Safety Evaluation Report

Renewal of the Facility Operating License for the TRIGA Nuclear Reactor at Reed College

U.S. Nuclear Regulatory Commission

April 2012

Figure 2-6 GA-7882, confirmatory, and RRR fuel temperature coefficients

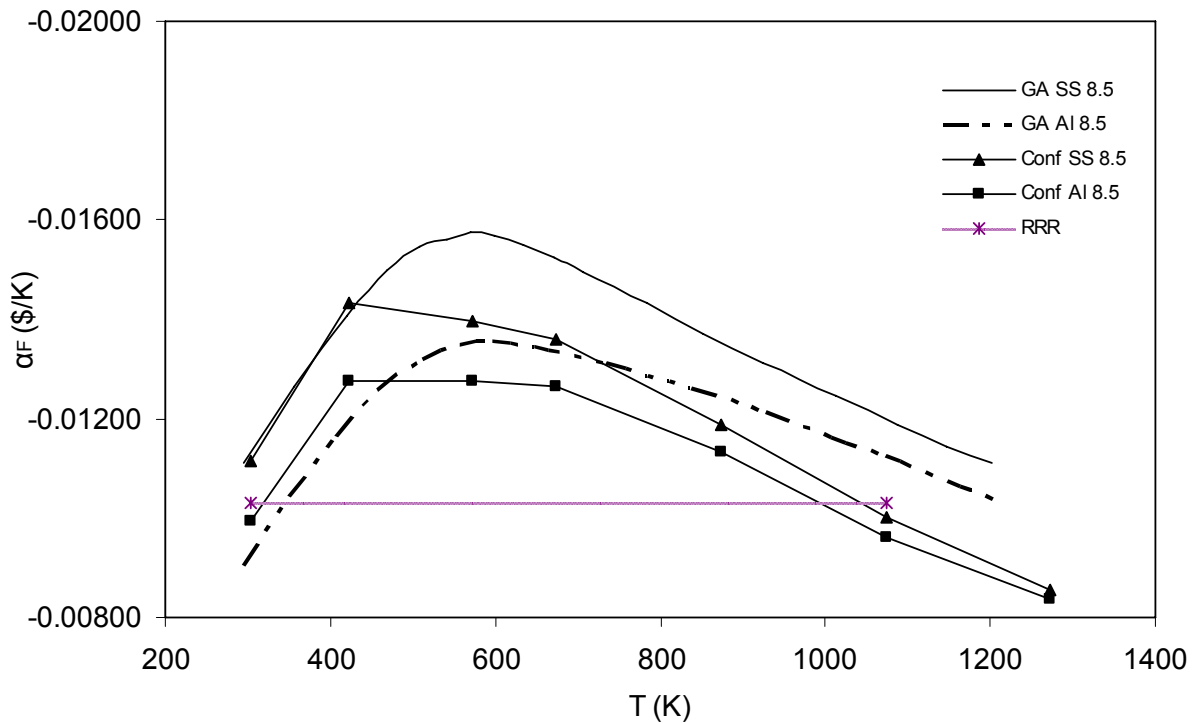
The reference GA results, NRC staff confirmatory results, and RRR's chosen value of -0.0103 \$/K, are displayed on Figure 2-6 above. The NRC staff finds that the FTC value the licensee selected, -0.0103 \$/K, provides less negative reactivity feedback than is physically available in the reactor; therefore, it is conservative for the safety analyses results. On the basis of the information provided above, the NRC staff concludes that the RRR FTC is, therefore, acceptable.

Figure 2-7 Uncontrolled rod withdrawal

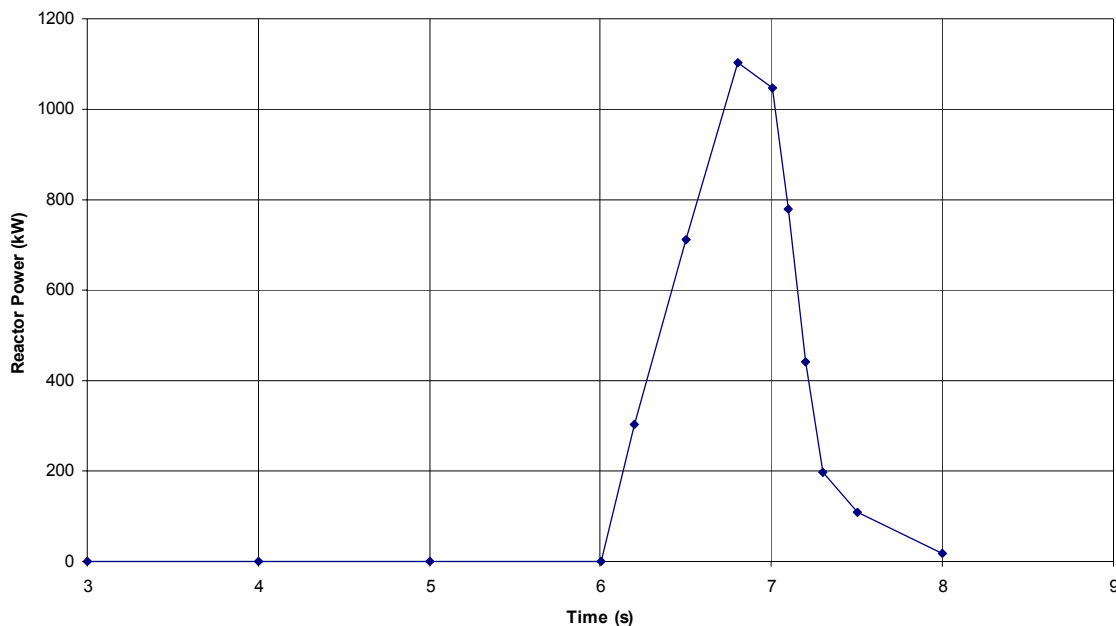
The scram signal occurs at 6.5 seconds at a power of 285 kW. Power continues to rise until the delay time is exhausted. At this time the peak power of 1,103 kW is attained very briefly. Because nuclear processes occur much more rapidly than thermal-hydraulic processes, the peak fuel temperature, which begins the transient at ambient temperature (25 degrees C), peaks at 51 degrees C. The results are shown in Figure 2-7.

The NRC staff finds that the peak power reached, for a very short time, does not pose a challenge to the fuel temperature SL or the DNBR because the time duration is extremely fast and the heat transfer so low that it cannot result in any appreciable temperature increase. Consequently, the confirmatory analysis substantiates the licensee's values provided in TS 3.2.1, Specification b, of 1 second for the control rod scram insertion time, and TS 3.2.1, Specification c, of \$0.16/s for the control rod withdrawal rate limit (see Section 2.2.2 of this SER).

Figure 2-10 Maximum fuel temperature as a function of fuel element power

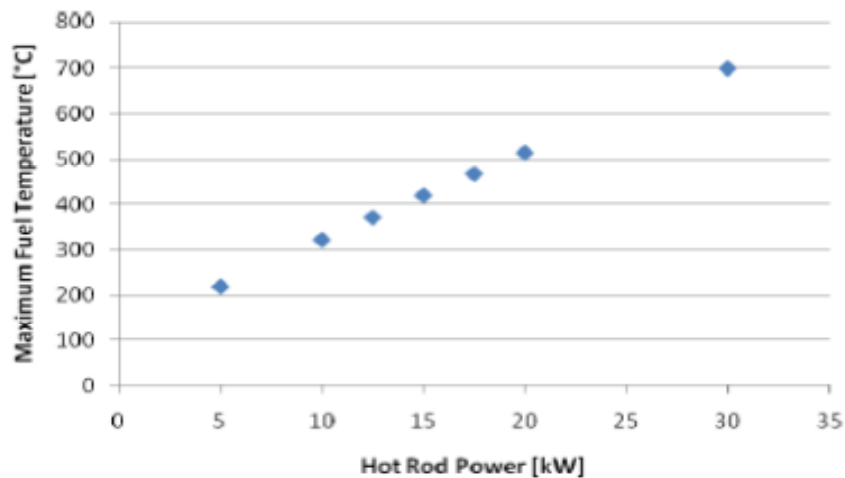
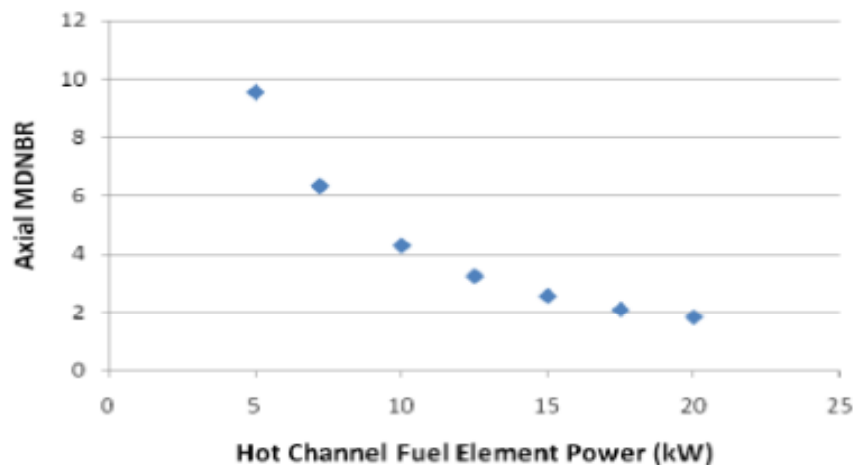
Figure 2-10 and Figure 2-11 illustrate that the RRR can be operated with an acceptable DNBR and at a fuel temperature below the TS 2.1 SL value of 1,000 degrees C. The RRR LCC minimum DNBR was calculated to be 6.33 at the maximum fuel temperature of 264 degrees C at 250 kW steady-state operation. The guidance in NUREG-1537 recommends a minimum DNBR of 2; therefore, the RRR minimum DNBR of 6.33 is well above the minimum DNBR value. The RRR DNBR was consistent with the values reported for other TRIGA research reactors with similar operating power levels.

Figure 2-12 TRACE model of the RRR

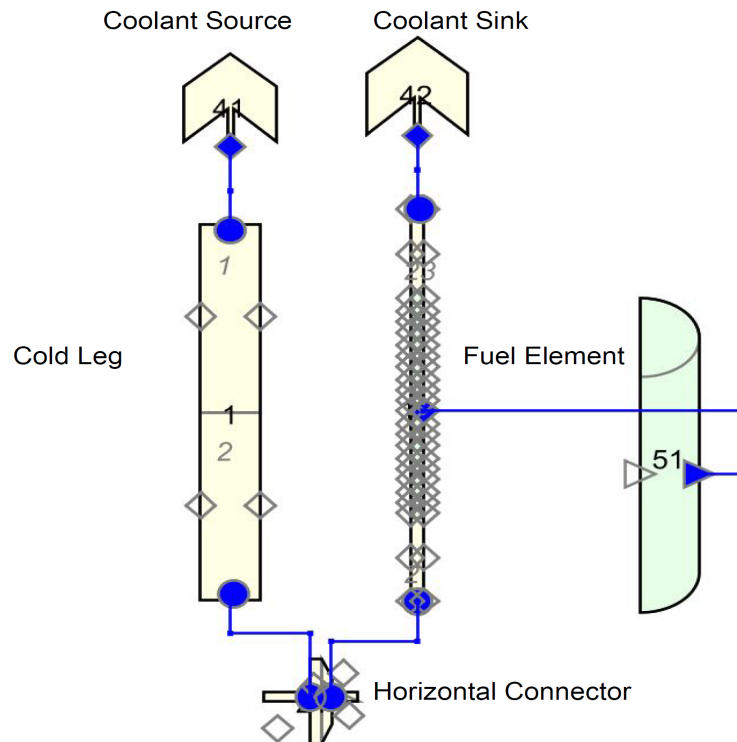
The NRC staff confirmed the calculation of the RRR DNBR using the TRACE computer code (Ref. 20). The model developed is displayed in Figure 2-12.

The TRACE model used the corrected physical characteristics from the RRR SAR and the Bernath correlation. The results of the two models provided acceptable agreement. The

Figure 2-14 Comparison of confirmatory and RRR DNBR results

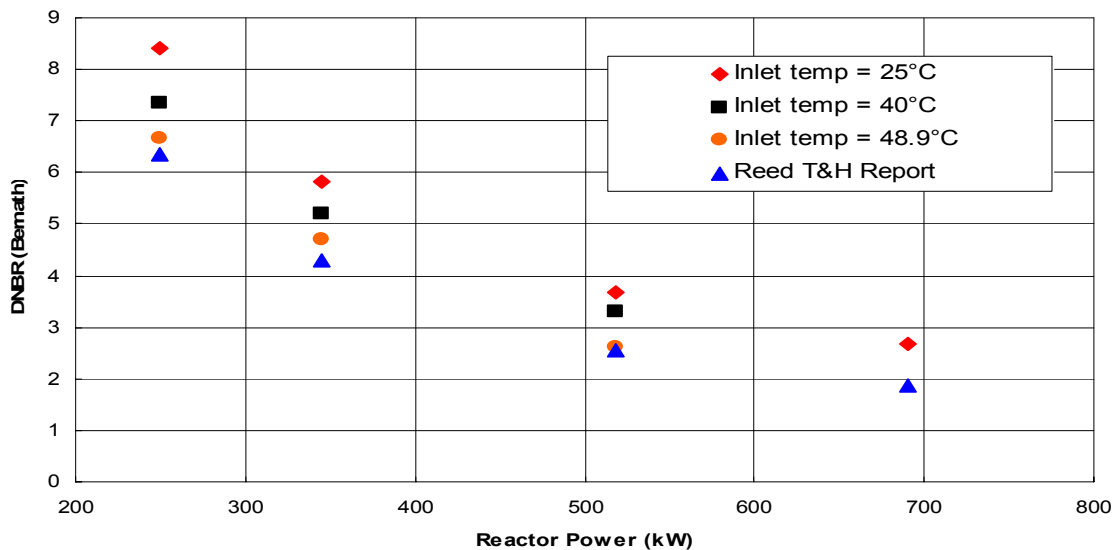
Figure 2-14 displays the TRACE calculated DNBR values as a function of reactor power. The calculations were performed using nominal inlet temperature (25 degrees C) and the TS limit on bulk pool temperature (40 degrees C) from TS 3.3, Specification b. The results illustrate acceptable agreement between the RRR thermal-hydraulic analyses using RELAP3-D and the confirmatory calculation results by the NRC using TRACE.

The NRC staff finds that the RRR thermal-hydraulic analysis for the RRR core adequately demonstrates that RRR can operate at the licensed power level of 250 kW with sufficient thermal-hydraulic safety margins. Furthermore, the NRC staff finds that its independent calculational results of the thermal-hydraulic analysis for the RRR provide a high level of confidence that RRR thermal-hydraulic match the actual core conditions at the licensed power level of 250 kW. Based on the information provided above, the NRC staff concludes that the RRR thermal-hydraulic analysis is, therefore, acceptable.

Figure 1 Administrative Structure

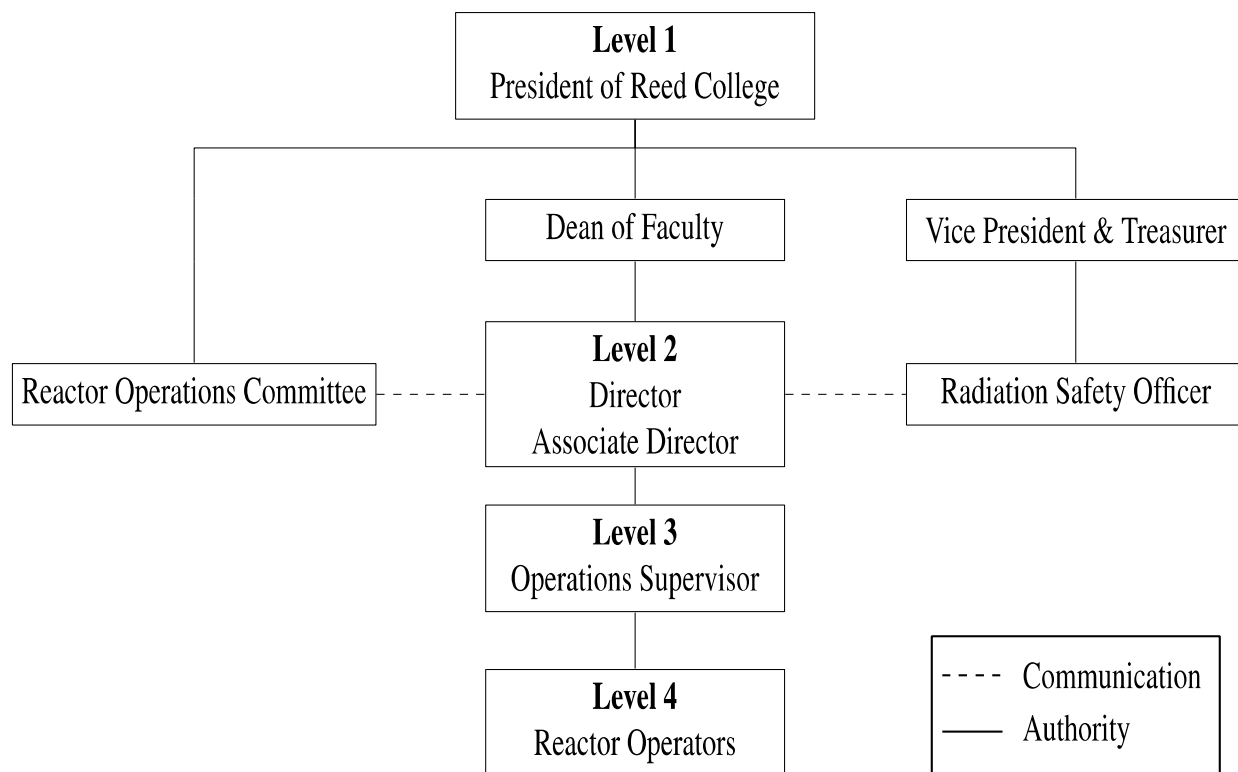
The NRC staff finds that the organizational structure described in TS 6.1.1 is consistent with the guidance in ANSI/ANS-15.1-2007 and NUREG-1537. On this basis, the NRC staff concludes that TS 6.1.1 is, therefore, acceptable.
